May 10, 2016

RE: Response to MDEQ Technical Comments Specific to Leak Detection System Isolation for Cells 20-22 Final Closure Design Submittal From Meeting on April 21, 2016
Salzburg Landfill, Midland, Michigan

SALZBURG LANDFILL
CELLS 20-22 FINAL CLOSURE PROJECT
WEST BERM CROSS SECTION

PROJECT NUMBER	SCALE		REV.
141499	AS NOTED	B2-013-141499	2

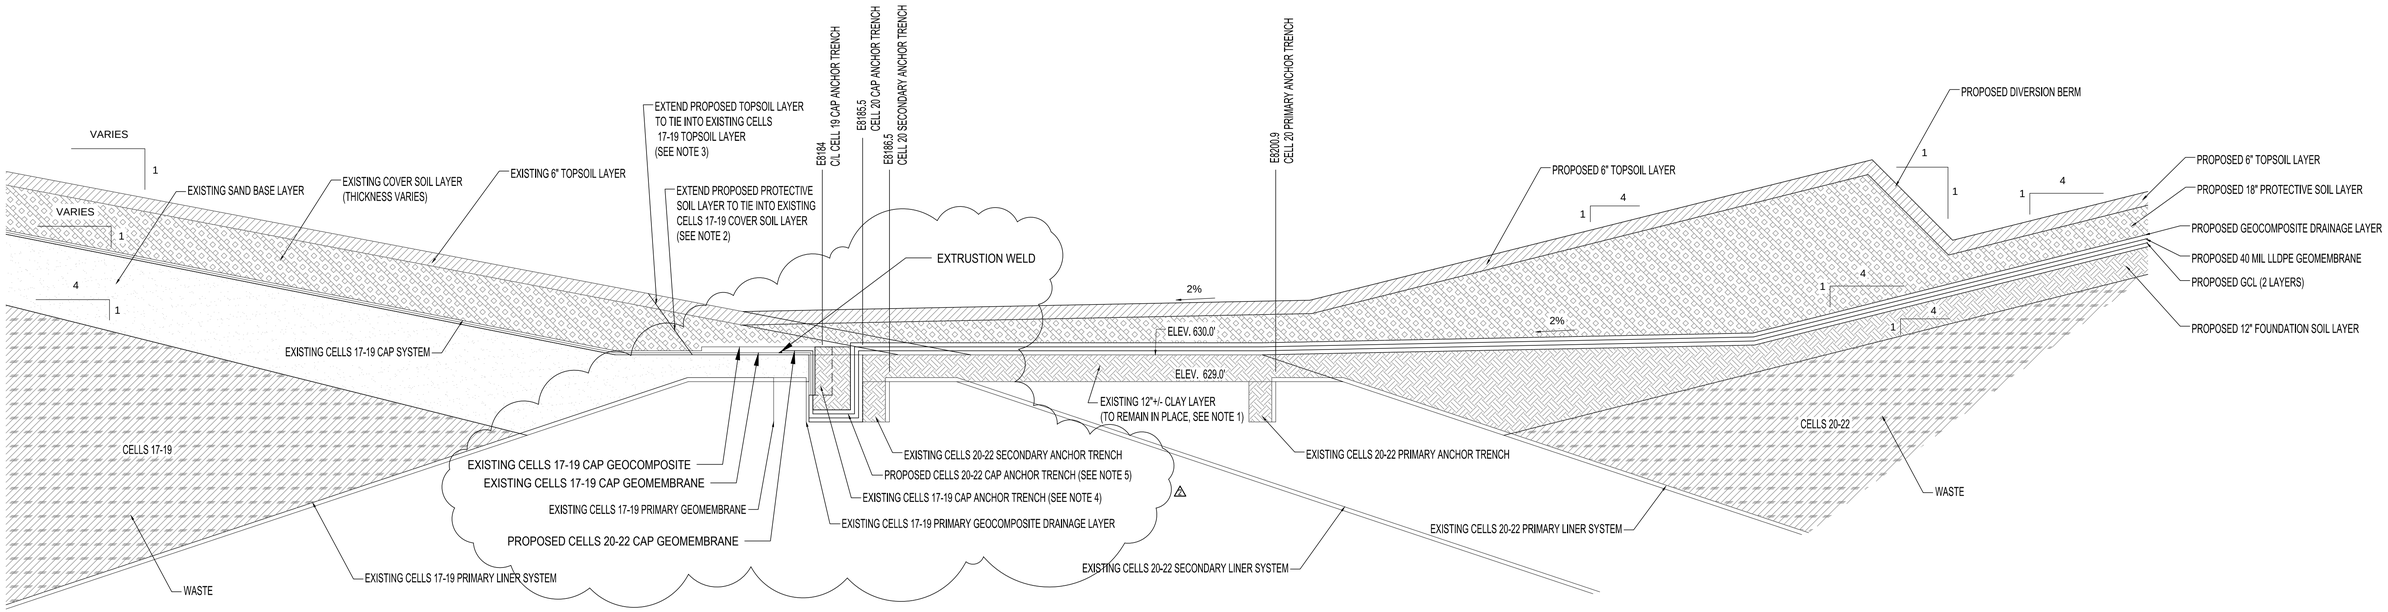
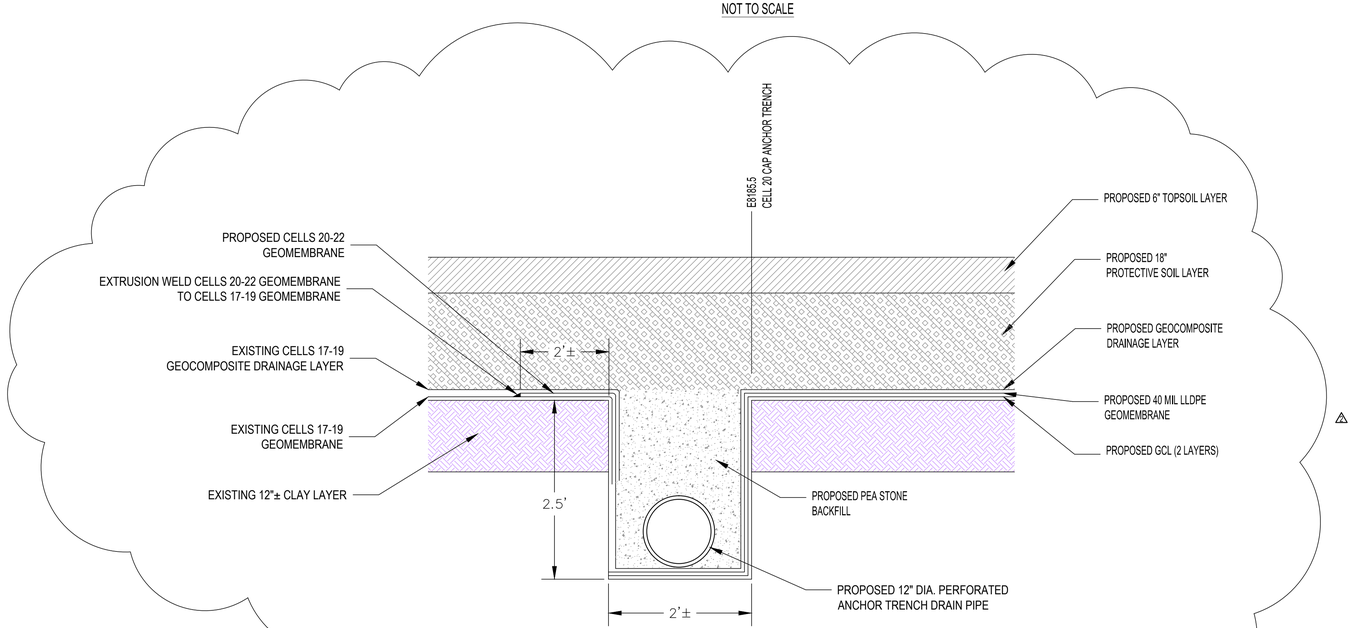
Comment 1: For the west berm, the concerns were raised about the proximity of the Cells 17-19 east berm final cover anchor trench, the Cells 20-22 west berm final cover anchor trench and the Cells 20-22 leak detection anchor trench.

Response 1: AECOM proposed to widen the Cells 20-22 west berm final cover anchor trench to include the Cells 17-19 east berm final cover anchor trench. This will require excavating the existing Cells 17-19 west berm final cover anchor trench, temporarily folding back the Cells 17-19 final cover geocomposite, extending the Cells 20-22 final cover geomembrane to at least 2-feet west of the top of the widened anchor trench, installing a continuous extrusion weld to attach the Cells 20-22 final cover geomembrane to the Cells 17-19 final cover geomembrane, re-installing the Cells 17-19 final cover geocomposite into the widened anchor trench, installing a new 12-inch diameter perforated HDPE drain pipe in the anchor trench, and backfilling the anchor trench with pea stone in accordance with the project specifications. This change is shown on the revised drawing B2-013-141499 and is included as Attachment A to this memo.

The new 12-inch diameter perforated HDPE anchor trench drain pipe was increased from the 8-inch diameter pipe previously proposed due to the increase in flow to the anchor trench from the east slope of Cells 17-19 final cover geocomposite. Design information pertaining to the Cells 17-19 final cover geocomposite was obtained from the Cells 17-19 Final Cover Design Submittal dated September 2004. This information was used in conjunction with the design information of the Cells 20-22 final cover geocomposite to adequately size the anchor trench drain pipe. The anchor trench drain pipe size had to be increased to 12-inch diameter in order to satisfy the flow capacity requirements of the geocomposite drainage layer inflow rate without exceeding the top of the anchor trench. The change in pipe size is reflected on revised sheet B2-013-141499 and is provided in Attachment A to this memo. The pipe capacity analysis is identified as Appendix J-1 to the Basis of Design Report, and is included as Attachment B to this memo.

4. EXISTING CELLS 17-19 CAP GEOSYNTHETICS ANCHOR TRENCH SHALL BE EXCAVATED AND THE GEOCOMPOSITE FOLDED BACK TO ALLOW FOR THE CELLS 20-22 GEOMEMBRANE TO BE WELDED TO THE CELLS 17-19 GEOMEMBRANE. UPON COMPLETION OF THE WELD THE CELLS 17-19 GEOCOMPOSITE SHALL BE LAID BACK INTO THE COMBINED ANCHOR TRENCH AND BACKFILLED AS SHOWN IN THE DRAWINGS. 2

5. PROPOSED CELLS 20-22 ANCHOR TRENCH SHALL INCLUDE, AND COMBINE, THE ANCHOR TRENCH FOR THE CELLS 17-19 CAP GEOSYNTHETICS. THE CELLS 20-22 CAP GEOMEMBRANE SHALL BE EXTENDED INTO, AND OUT THE WEST SIDE OF, THE ANCHOR TRENCH AND WELDED TO THE CELLS 17-19 CAP GEOMEMBRANE WITH A CONTINUOUS EXTRUSION WELD ALONG THE ENTIRE LENGTH OF THE WEST BERM ANCHOR TRENCH.

FIGURE 1

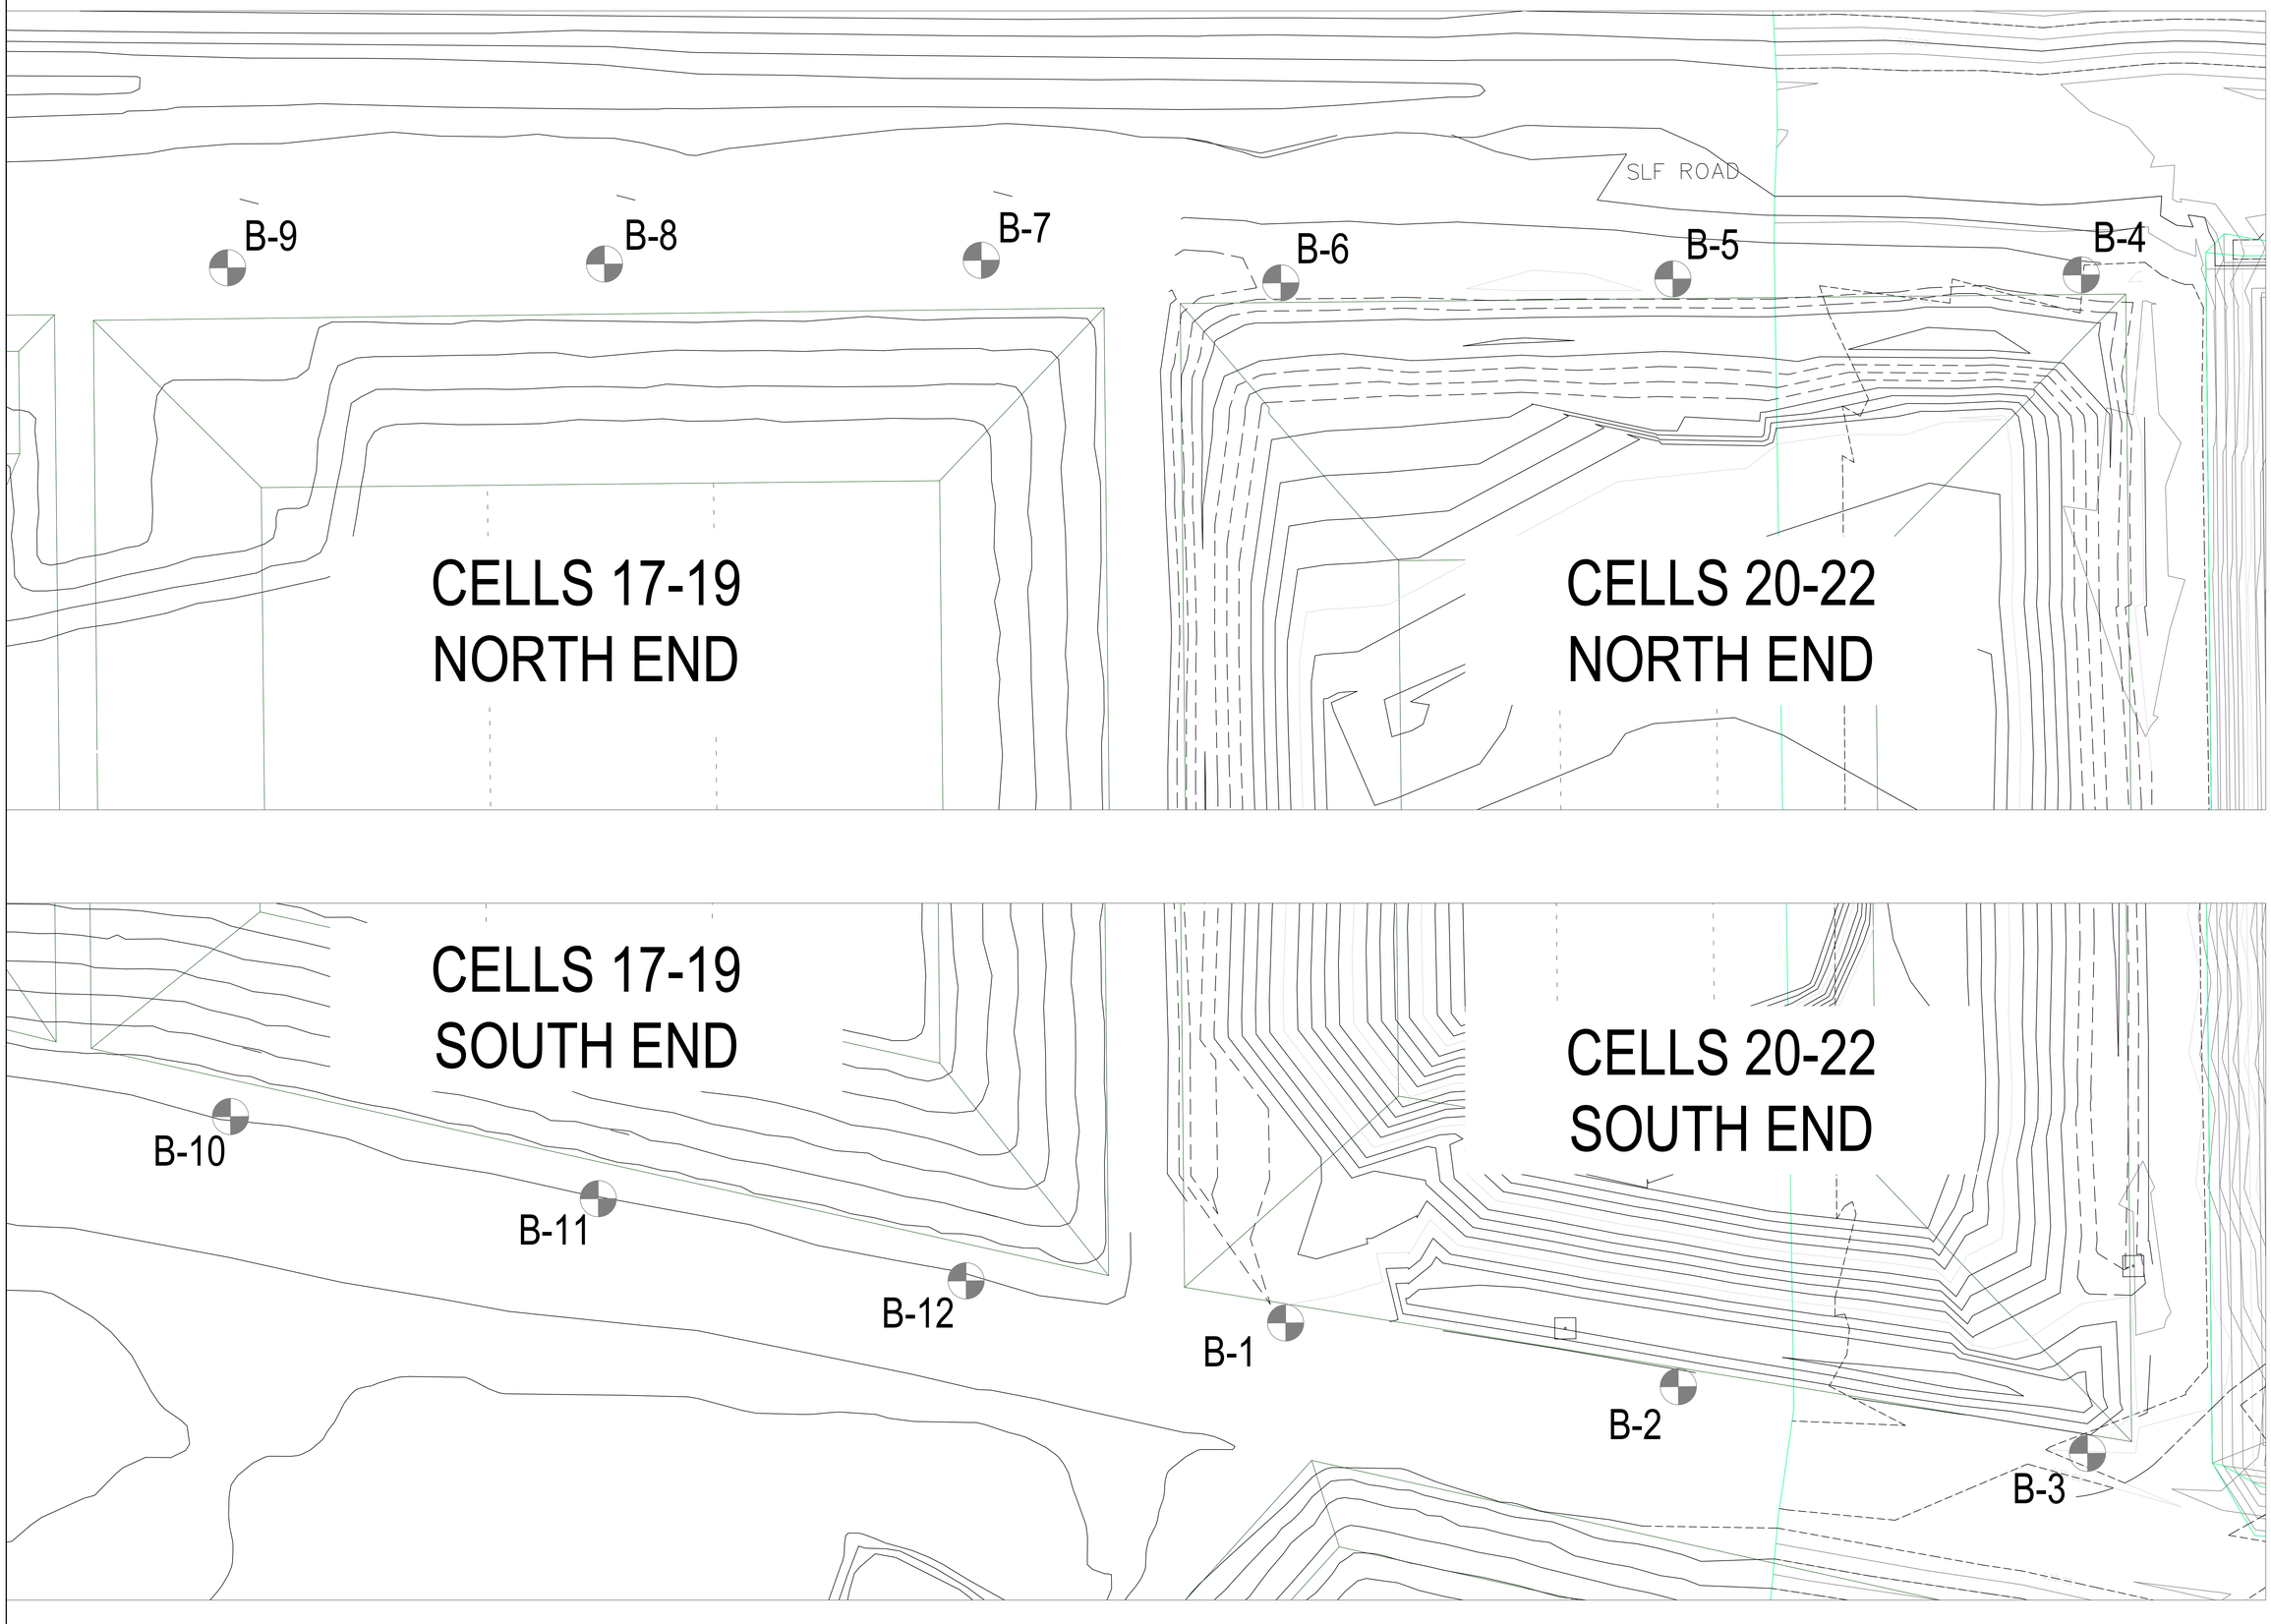
Comment 2: For the north and south berms, the concern was raised about the possibility of storm water and/or shallow groundwater infiltration into the Cells 20-22 leak detection anchor trench.

Response 2: AECOM conducted a series of profile soil borings along the north and south sides of Cells 20-22, adjacent to the leak detection anchor trench, to determine if the existing compacted clay liner soils are saturated by storm water and/or shallow groundwater. A total of twelve (12) profile soil borings were completed, six (6) of which were adjacent to Cells 20-22. The borings for Cells 20-22 were identified as B-1 through B-6. The borings were advanced to the depth of the leak detection system anchor trench and were located approximately 2-feet outboard, or away from, the anchor trench. The locations of the soil borings are shown on Figure 1 and are provided as Appendix L to the Basis of Design Report, and are provided as Attachment C to this memo. The borings were advanced to a depth of 6-feet below existing ground surface which corresponds to approximately 1-foot below the top of the leak detection anchor trench. Soil samples were collected off of the augers at approximately 5-feet below ground surface elevation and were analyzed for moisture content in accordance with ASTM D-2216. The results of the analyses are summarized below in Table 1.

The moisture content results from the borings were then compared to the moisture-density test results of the compacted clay liner at the time of installation in 2000. According to the report titled "As-Built and Construction Certification for Salzburg Landfill Cells 20, 21 and 22" dated January 18, 2001 by Dow, the optimum moisture content of the clay material used for the construction of the compacted clay liner ranged from 7.7% to 9.5% as determined by the modified proctor test method ASTM D-1557. The specified moisture content for the compacted clay liner was from 0% to 5% above the optimum moisture content. Based upon this as-built data, the clay samples obtained from the six borings located adjacent to the Cells 20-22 leak detection anchor trench are within the acceptable range of moisture as it was installed in 2000 with two samples being only slightly above the specified range. It is concluded that the existing compacted clay liner is not saturated and has not been adversely impacted by surface water or shallow groundwater infiltration. Therefore, no design modification to the anchor Cells 20-22 final cover anchor trench is required for the north and south berms.
